Wright Solar Park Habitat Conservation Plan Draft Environmental Assessment Errata

Wright Solar Park Habitat Conservation Plan Environmental Assessment Comments and Responses to Comments

Figure 2-1
Wright Solar Park, LLC
Project Facilities

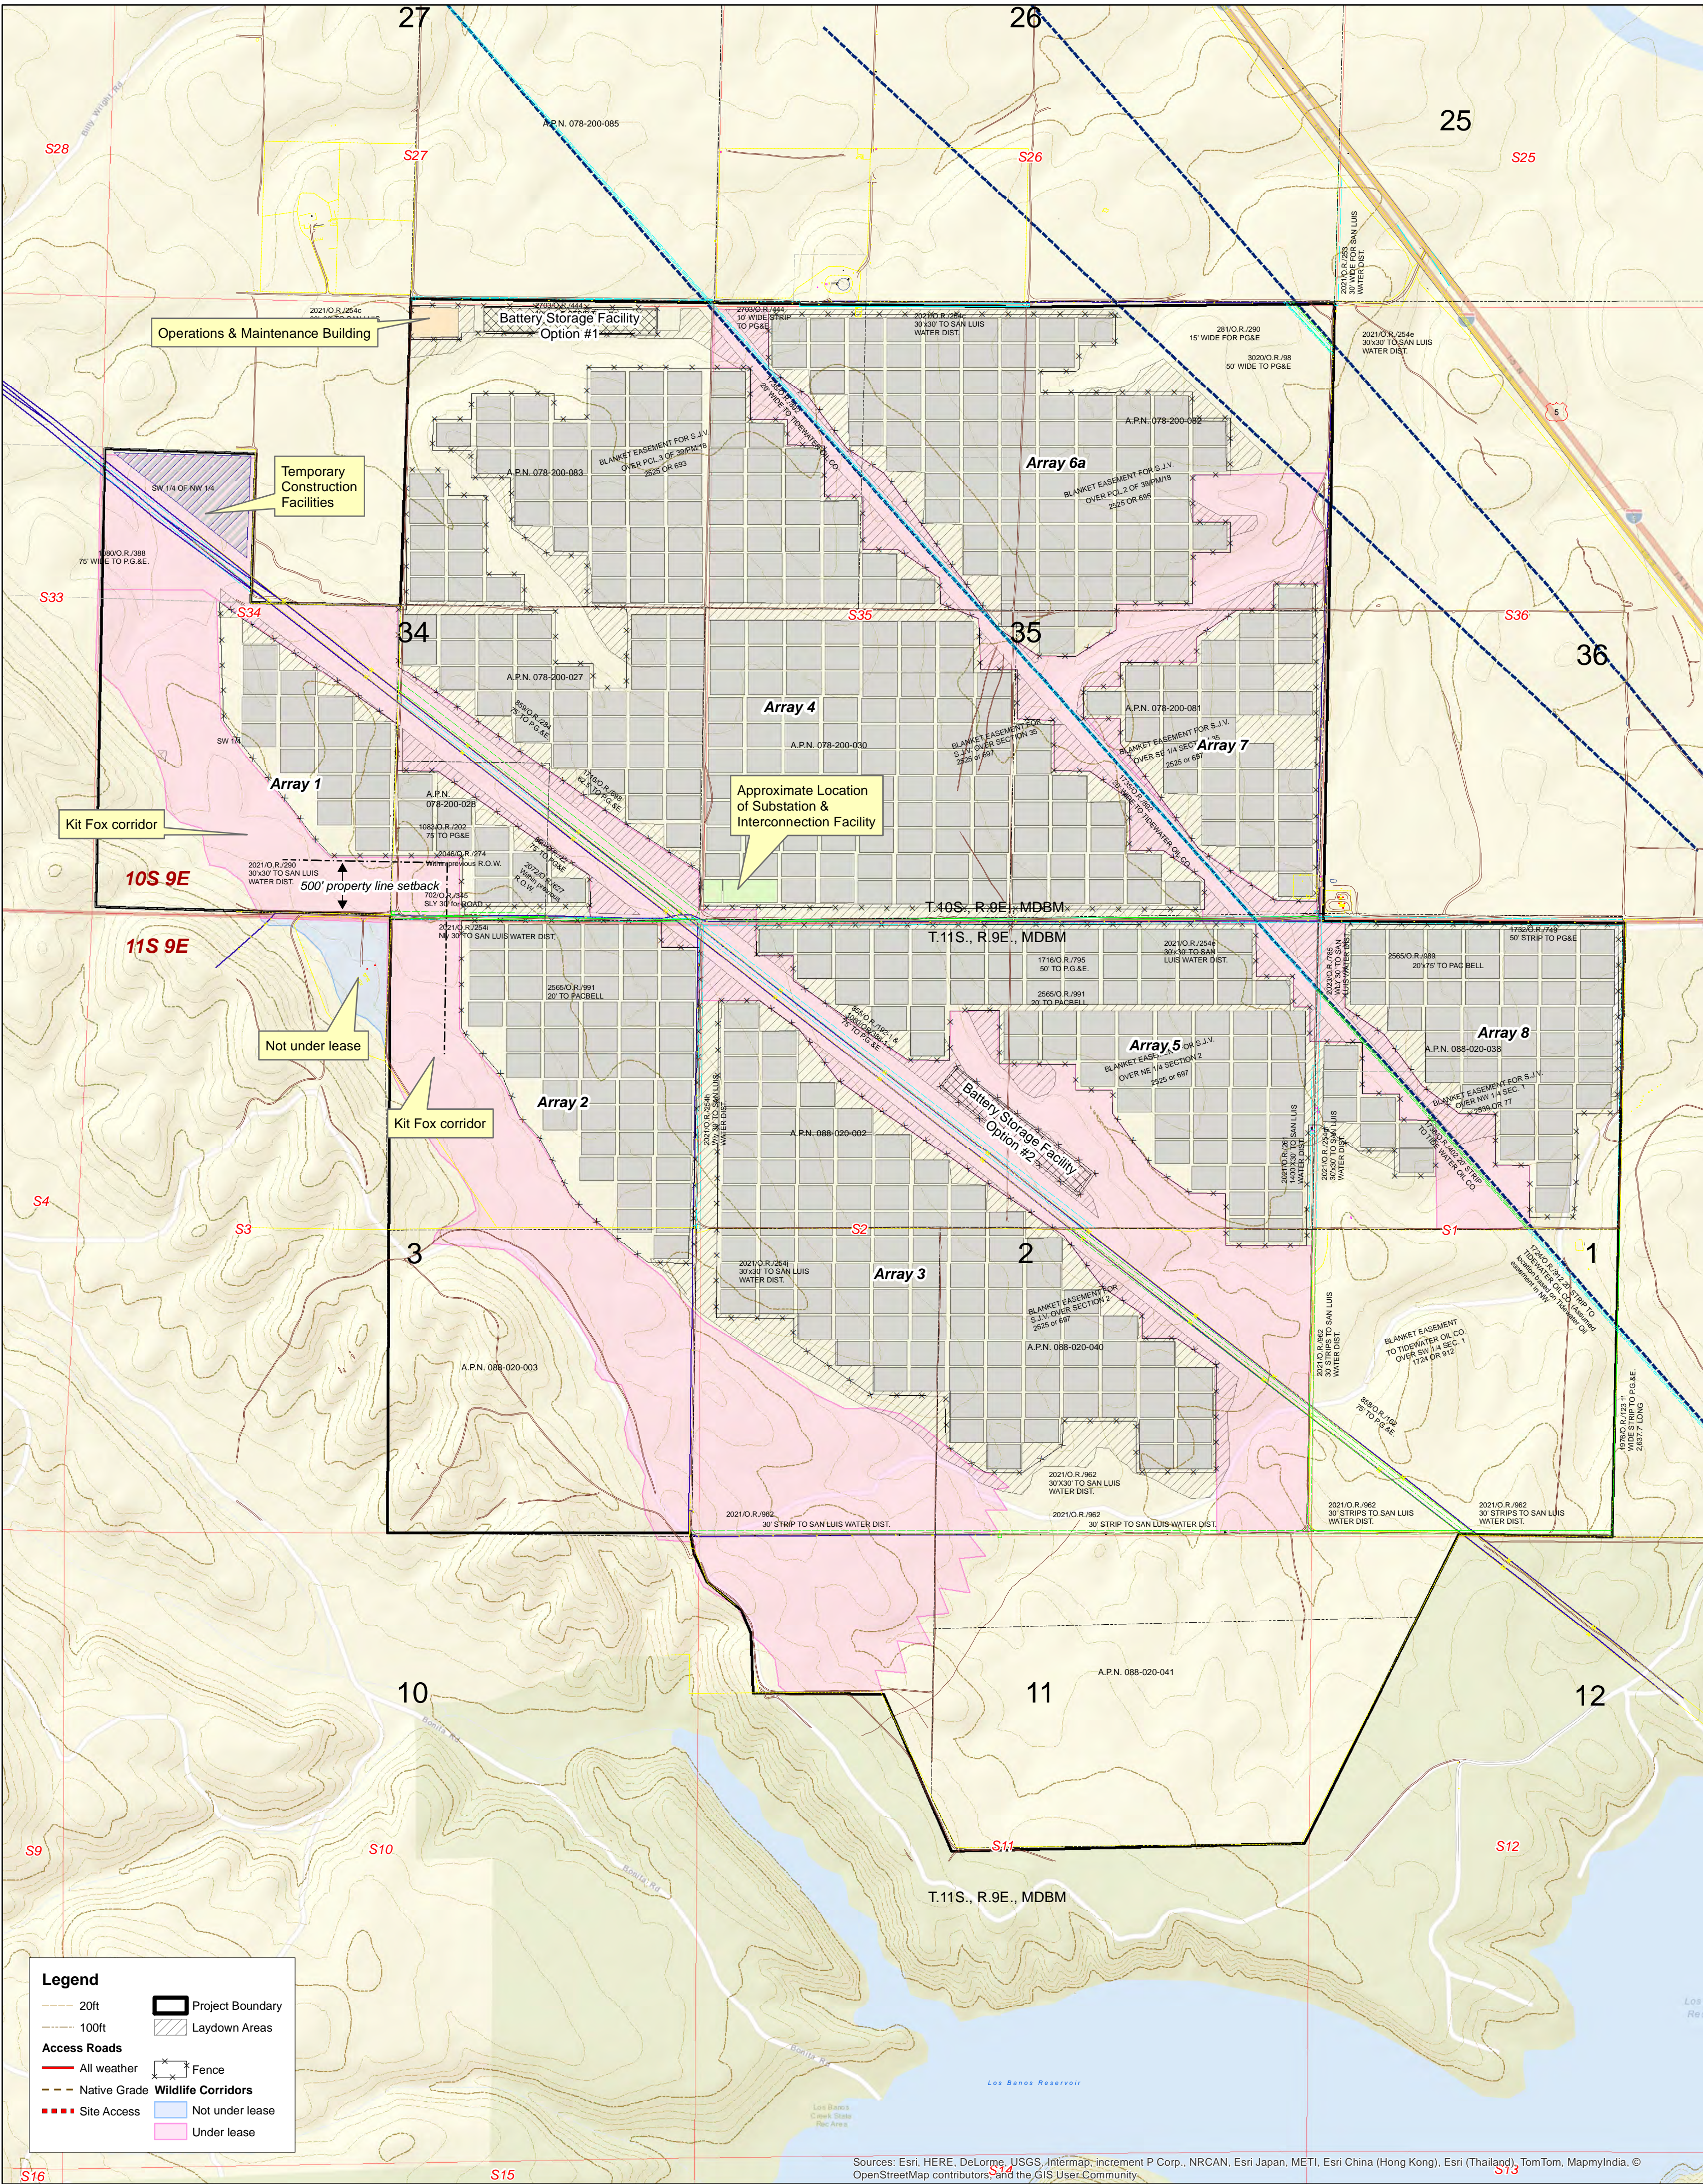
Figure 2-1	2-25	Figure 2-1 in the Draft EA is replaced with the attached (revised) Figure 2-1 which depicts the new buffer provided on the west side of the project site to allow for San Joaquin kit fox movement.
